Addendum No. 2
to
Invitation For Bids
IFB-21-HHL-002

Panaewa Lot 185 Site Improvements

Pre-bid Meeting minutes and Sign-in sheet
9:00 a.m., Thursday, February 25, 2021

ADDENDUM 2

GRADING AND EROSION CONTROL PLAN
SCALE: 1"=60'

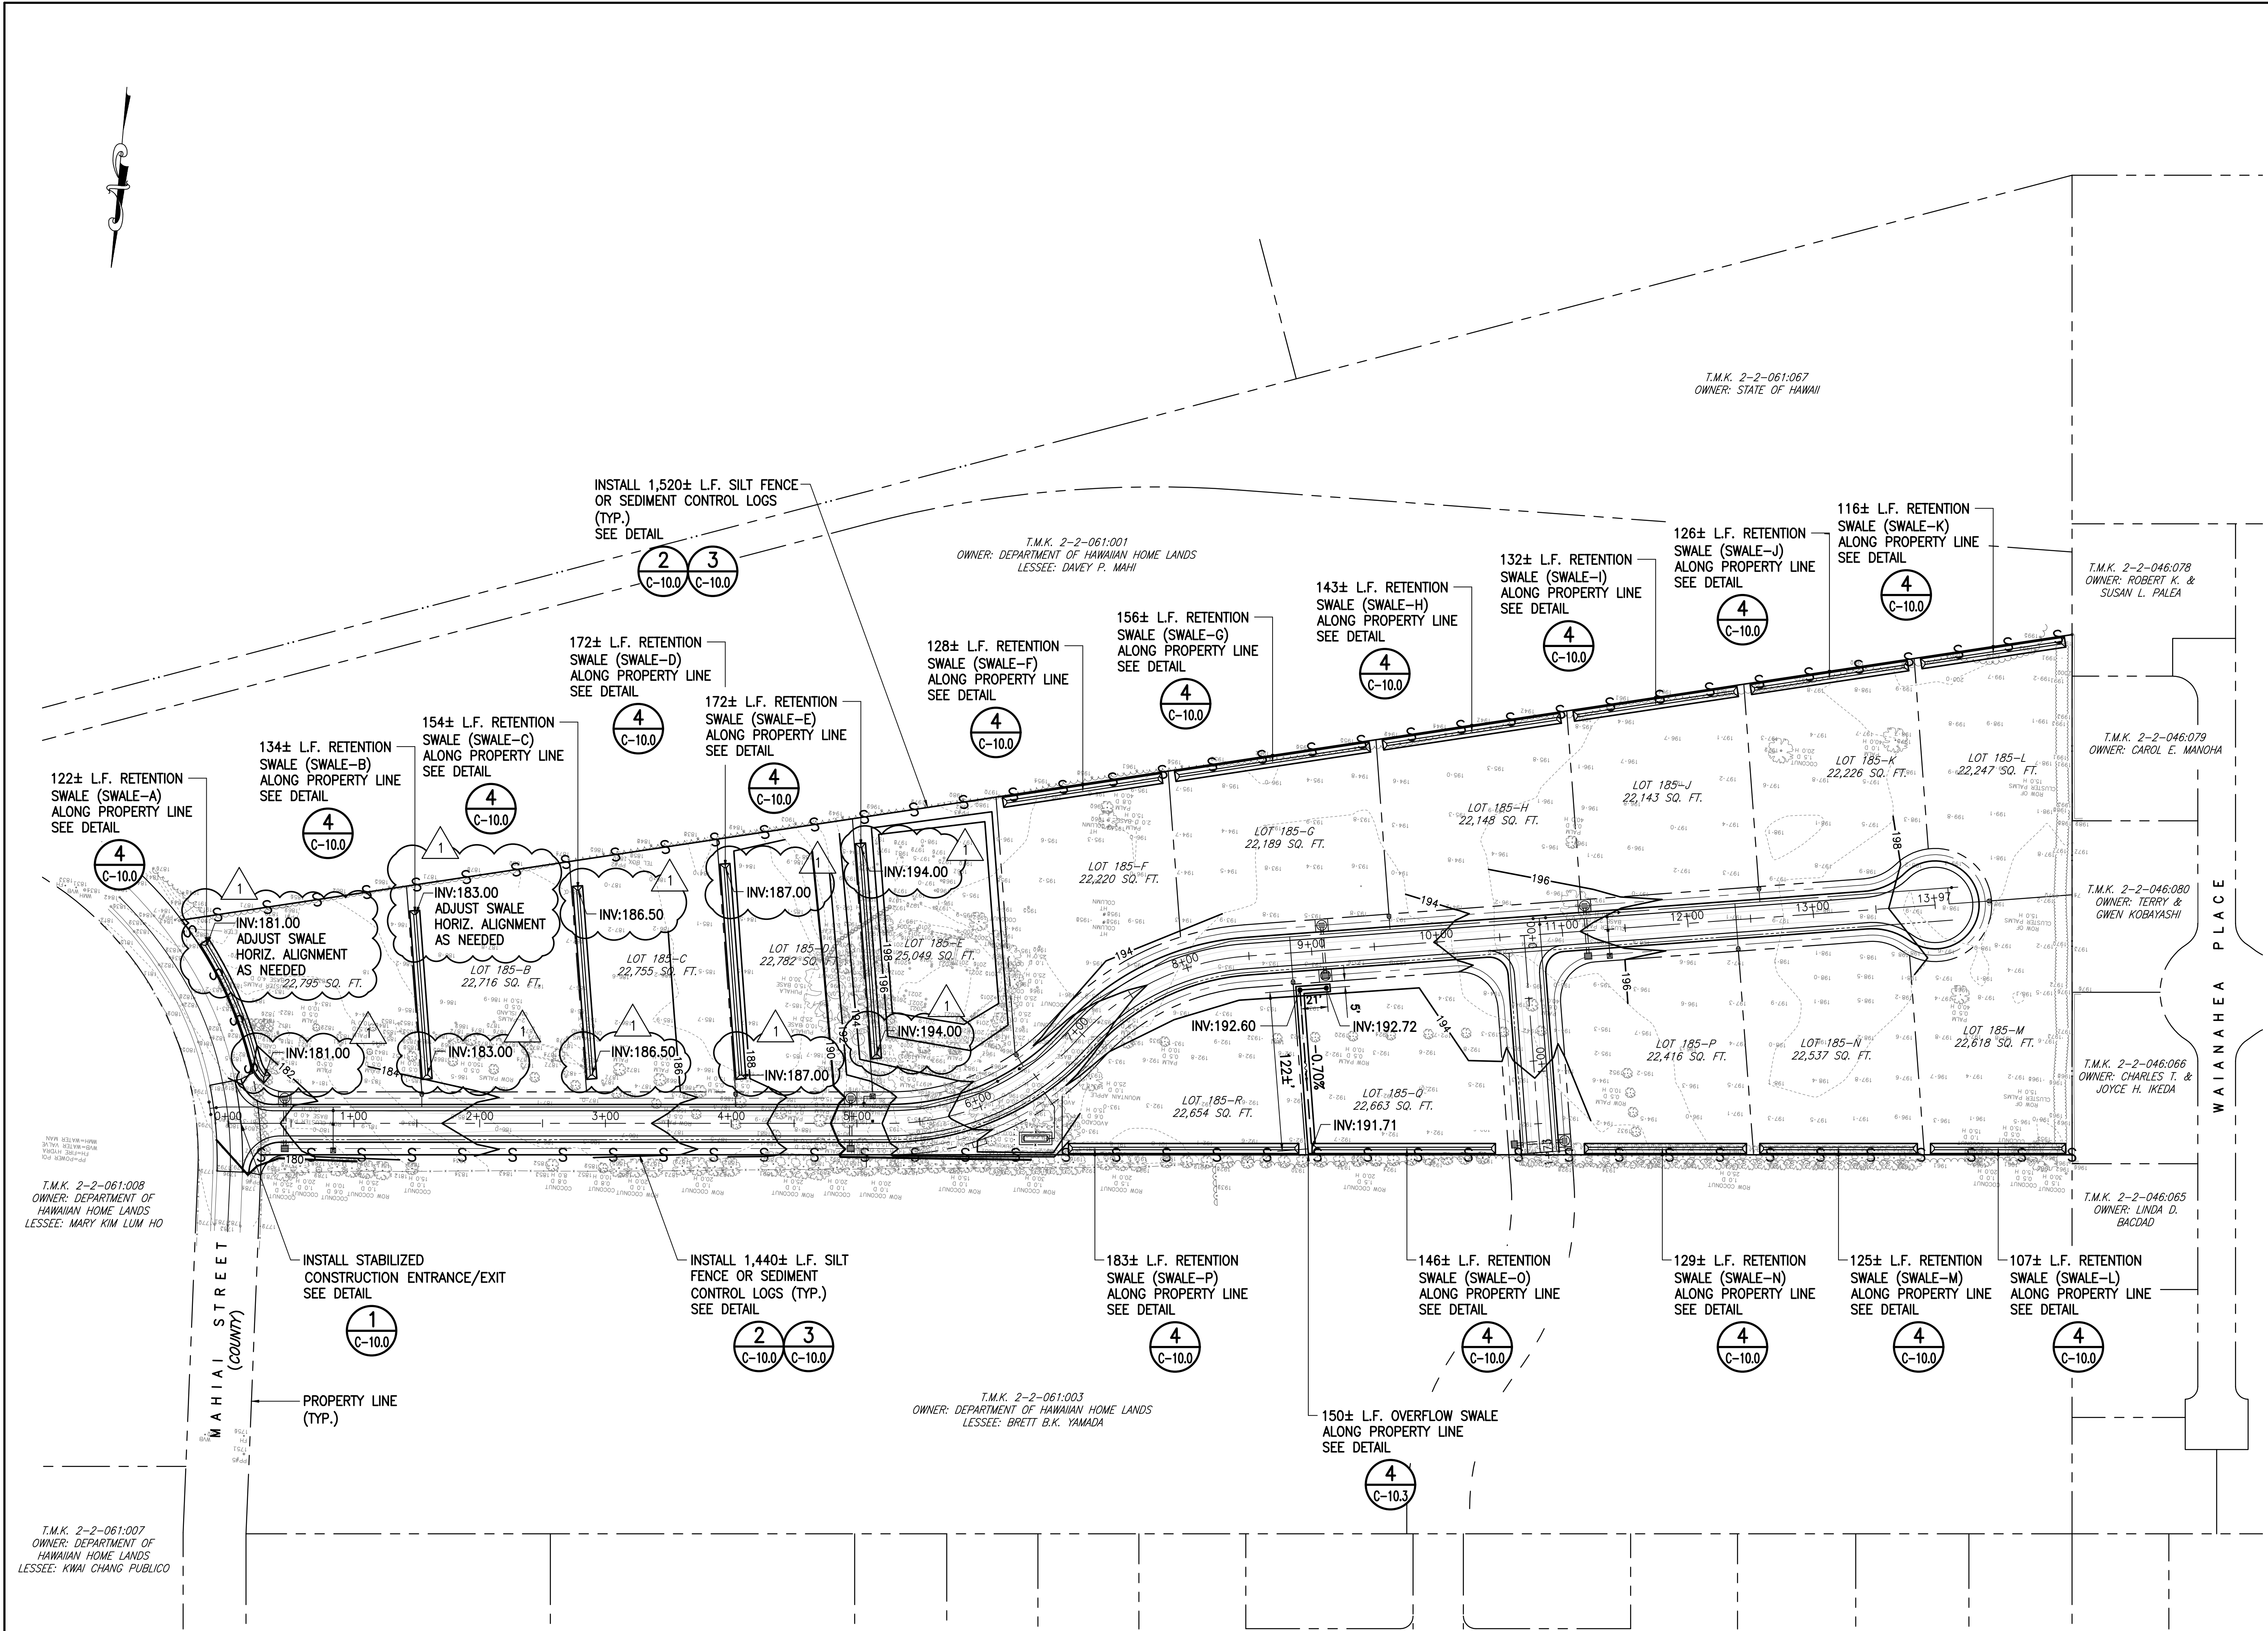
Revisions		
No.	Date	Description
1	03/01/21	ADDED SWALE INVERT ELEVATIONS
